# 3 SUB2006-00265

## STANDARD CONCRETE MOBILE SUBDIVISION

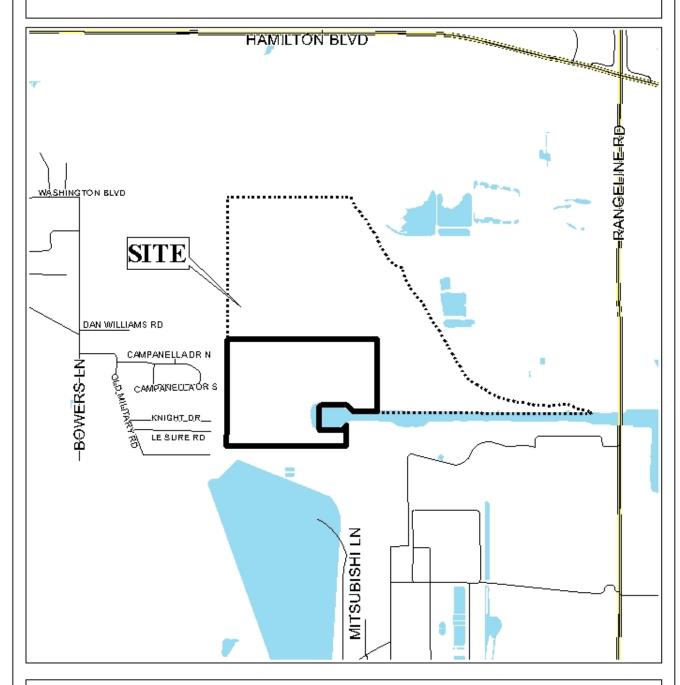
<u>Engineering Comments:</u> Must comply with the Mobile County Flood Damage Prevention Ordinance.

While the site is in the County, the applicant's engineer will be required to certify that the stormwater detention, drainage facilities, and release rate comply with the City of Mobile stormwater and flood control ordinances, prior to the signing and recording of the final plat, if approved.

This site is located in Mobile County, thus a note should be placed on the Final Plat stating that any lots which are developed commercially and adjoin residentially developed property must provide a buffer, in compliance with Section V.A.7. of the Subdivision Regulations.

The plat is recommended for Tentative Approval, subject to the following conditions: 1) provision of a certification letter from a licensed engineer to the Planning Section of Urban Development, certifying that the stormwater detention and drainage facilities comply with the City of Mobile stormwater and flood control ordinances, prior to the signing and recording of the final plat; and 2) placement of a note on the Final Plat stating that any lots which are developed commercially and adjoin residentially developed property must provide a buffer, in compliance with Section V.A.7. of the Subdivision Regulations.
